Date: April 12, 2024
To: All Prospective Bidders
From: Sam Li
Interim Director of Procurement Services
Re: Addendum Number 3
IFB # C1625 – Kaufman Residence Hall Corridor Carpet and Full Cove Base Replacement, Floors 12-15

PROJECT:
 KAUFMAN RESIDENCE HALL
 CORRIDOR CARPET & FULL FLOOR
 COVE BASE REPLACEMENT
 FLOORS 12-15
 406 W 31st STREET
 NEW YORK, NY 10001

1 TYPICAL FINISH FLOOR PLAN - FLOORS 12, 13 & 14
 SCALE: 3/32" = 1'-0"

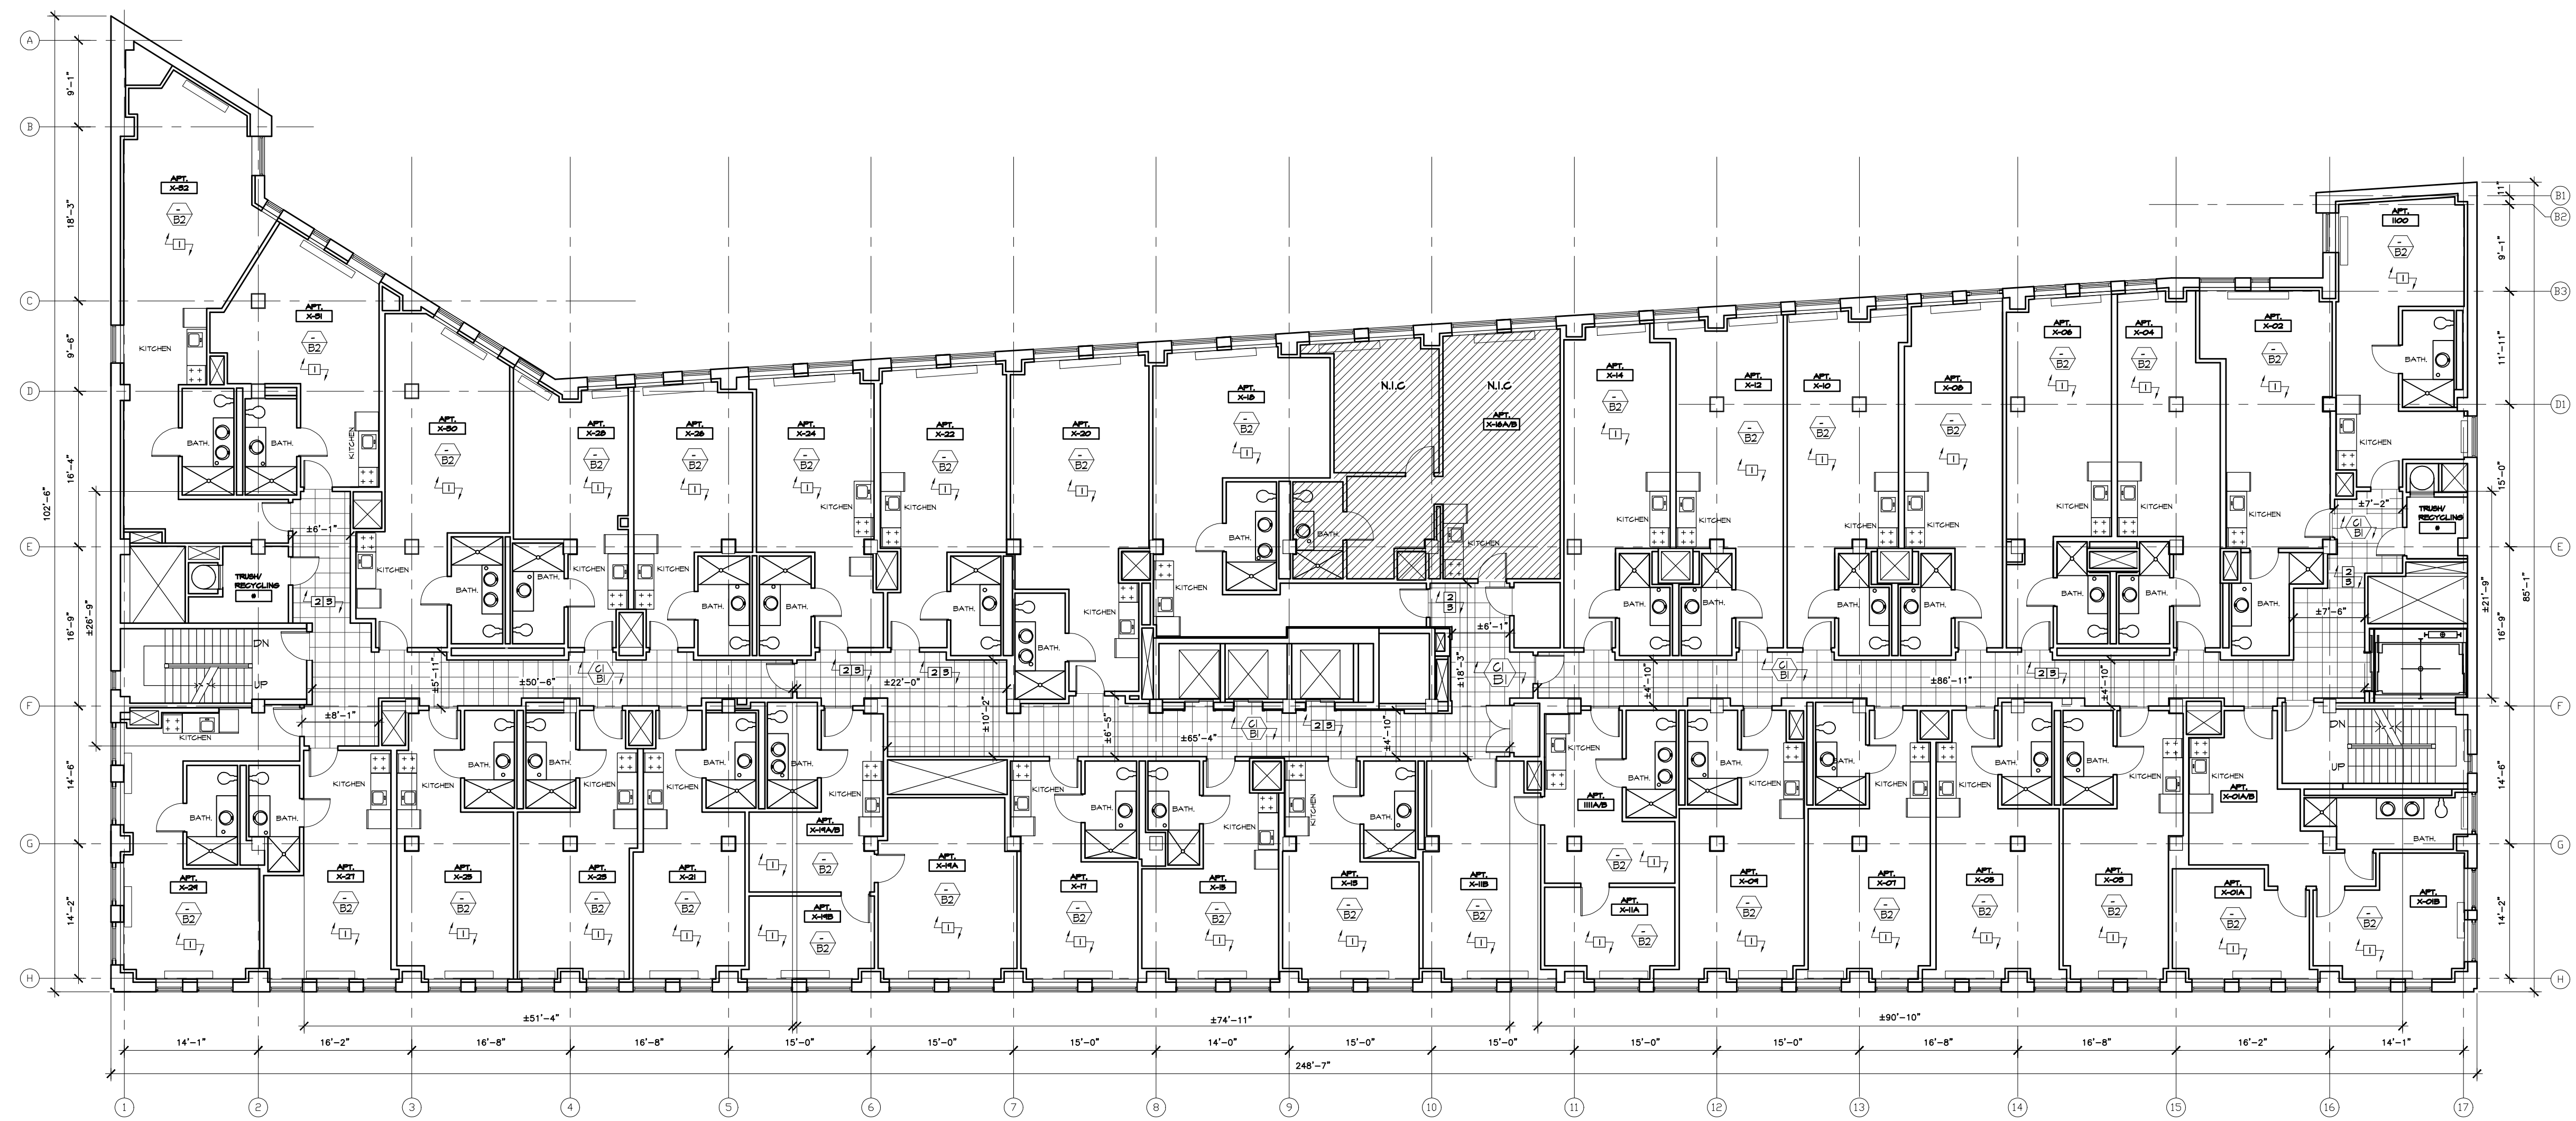
Note # 3 on work notes on sheets A-800 & A-801 has been updated to the following:
- Install floor patching throughout corridor. Feather the floor slab at base of walls as required. New 4” base to cover line of removed base.

3 INSTALL FLOOR PATCHING THROUGHOUT CORRIDOR. FEATHER THE FLOOR SLAB AT BASE OF WALLS AS REQUIRED. NEW 4" BASE TO COVER LINE OF REMOVED BASE.
